SERVICE PROCEDURE

22524 / 22537
JANUARY, 2023

SUBJECT: SAFETY RECALL 22524 Variation 22537
Hex Flange Lock Nut on certain International® HX®
Series trucks built 02/22/2022 thru 08/16/2022.

Figure 1. Sheppard Main Steering Gear Mounting Nuts (Driver-Side)

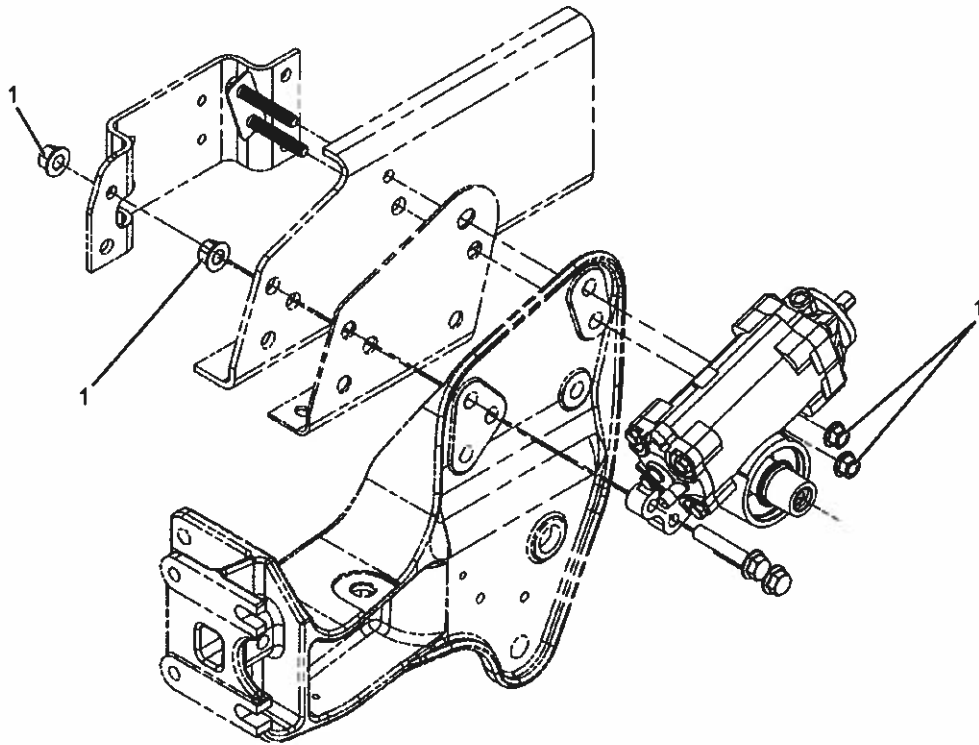
A specific hex flange lock nut used in several, but not all, steering and / or suspension locations may have not been properly formed and heat treated to Navistar's specifications and can result in a loss of joint tension as the vehicle ages. A loss of joint tension in these joints may affect vehicle handling and could contribute to a vehicle crash.

1. Main steering gear mounting nut (4)
6. Access main steering gear mounting nuts (Figure 1, Item 1).
7. Remove only one mounting nut at a time. Discard nut.

NOTE: After installation of each nut, ensure at least one thread is protruding past the top edge of the nut.

8. Install new mounting nut.
9. Using a torque wrench and backup wrench positioned on bolt, tighten mounting nut to 330 - 370 lb-ft (450 - 500 N·m).
10. Repeat Steps 7-9 for additional mounting nuts.
11. Close and latch hood.
12. Remove wheel chocks.
